## **DETAILED ACTION**

Art Unit: 3676

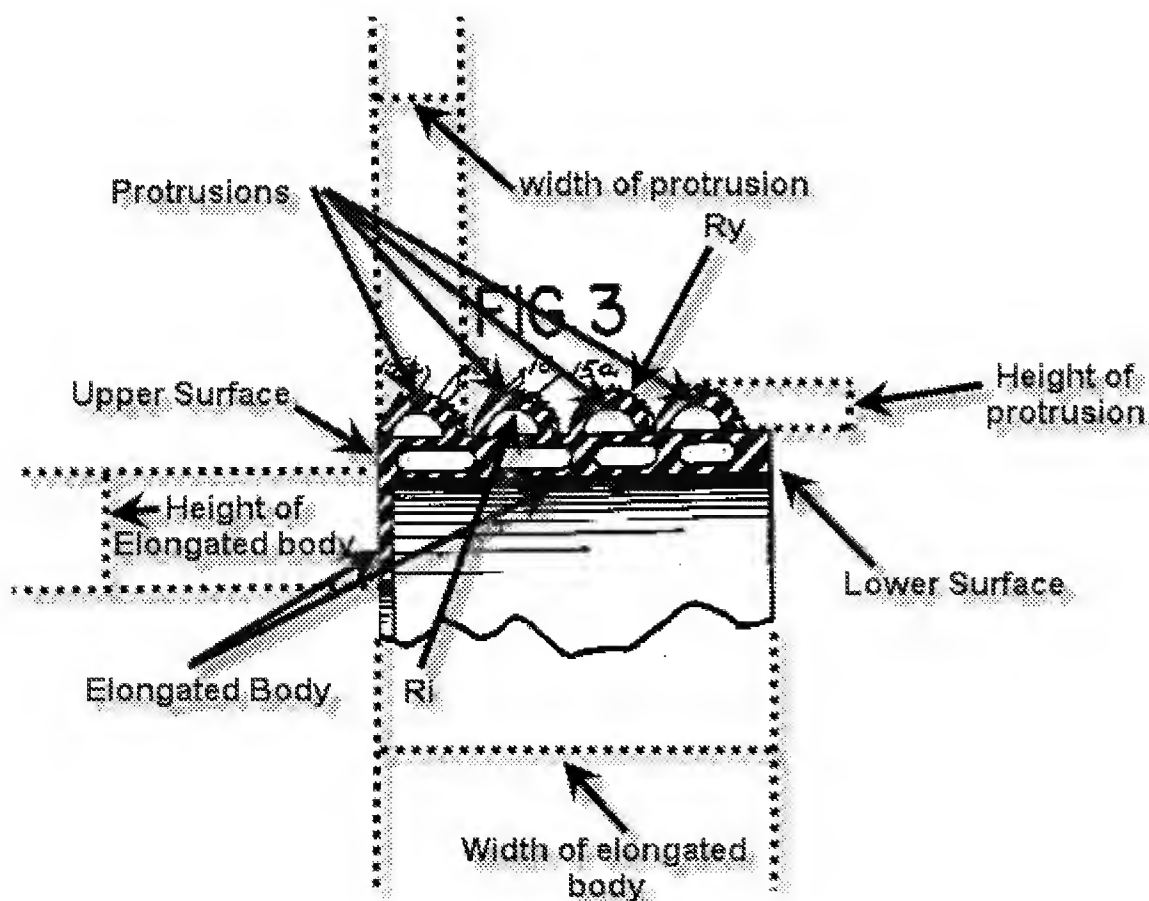
Regarding claims 4-9 and 13-19: Each of the protrusion has an upper delimitation surface and a lower delimitation surface (e.g. upper surface of 15 which adjacent to the upper surface of the elongated body) and projections of the upper and lower delimitation surface of the protrusions in parallel width of the elongated body are located between the upper surface and lower surfaces of the elongated body (e.g. the protrusion are between the upper surface and

lower surface of the elongated body). The protrusion each exhibit an extension in height-direction which is smaller than the extension in height of the elongated body (e.g. see figure below).

Each of the protrusions exhibits an outer side surface facing away from the elongated body and an inner side surface facing towards the elongated body (e.g. surfaces having  $R_y$  and  $R_i$ ), the inner side surface is curved and exhibits a maximum radius of curvature  $R_i$  and the outer side surface is curved and exhibits a maximum radius of curvature  $R_y$  and the maximum radius of curvature of the outer side surface is larger than the maximum radius of curvature of the inner side surface (e.g. this would be the case since the curve on the inner surface forms a smaller circle than the curve on the outer surface).

10. Applicant's arguments with respect to claims have been considered but are moot in view of the new ground(s) of rejection. Furthermore limitations of the claims are clearly shown in figure above of Nathan. No claims are indicated to be allowable.
